H11009

DESCRIPTIVE REPORT

General Locality TONGASS NARROWS

Descriptive Report to Accompany Hydrographic Survey H-11009

Figure D.2.1: Boundary of Annette Island and Reserved Waters

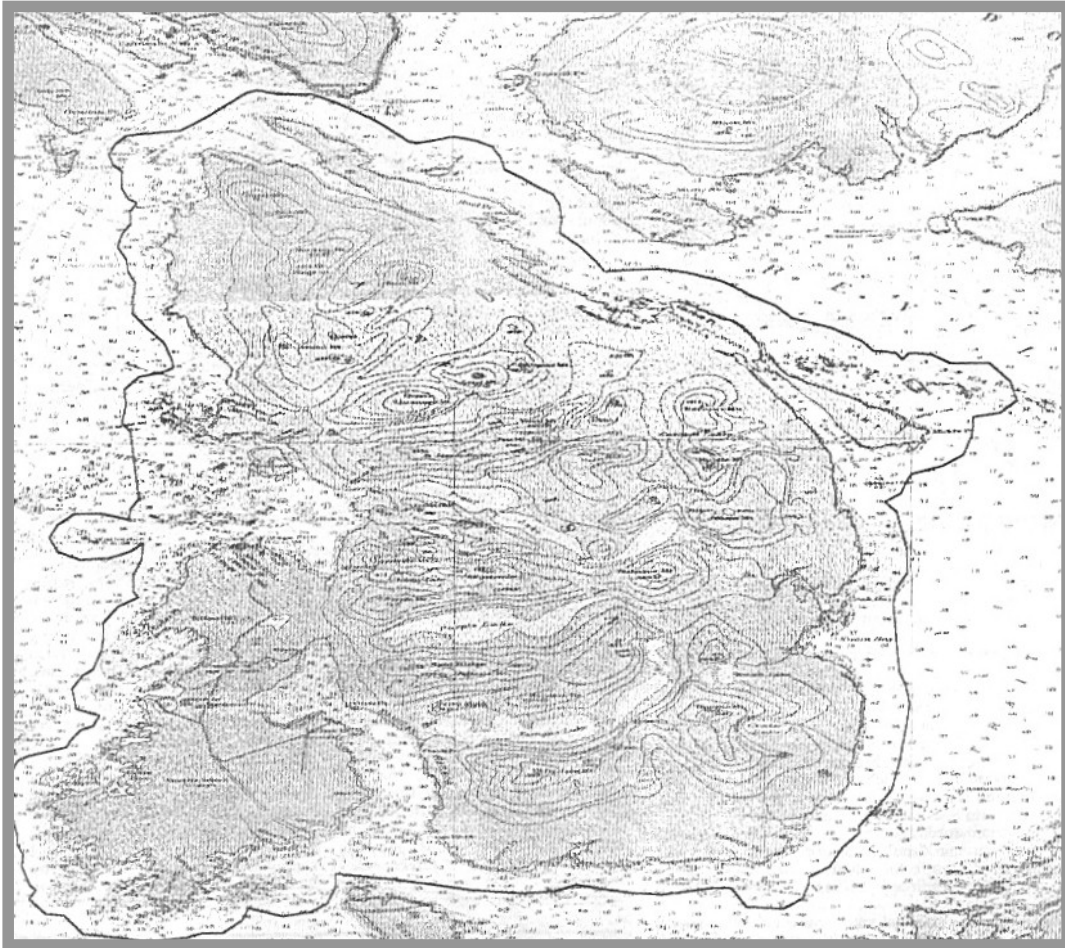
Two new features were discovered inside the survey limits, both within the reserved waters of the Annette Island Indian Reservation, shown in Figure D.2.1.¹ These features were not designated Items to Be Investigated within the scope of the survey, and no standard detached positions were taken.³³ The new features were positioned and digitally photographed in the course of Limited Shoreline Verification.³⁴ The information is included in the MapInfo database under the Workspace file *Ketch_ITBI.wor* and is summarized below in Table D.2.1.³⁵

³³ Do not concur, the detached positions were taken, see table D.2.1 and the smooth sheet for the depiction of these features.

³⁴ Concur, these two features are drawn in red at their surveyed position.
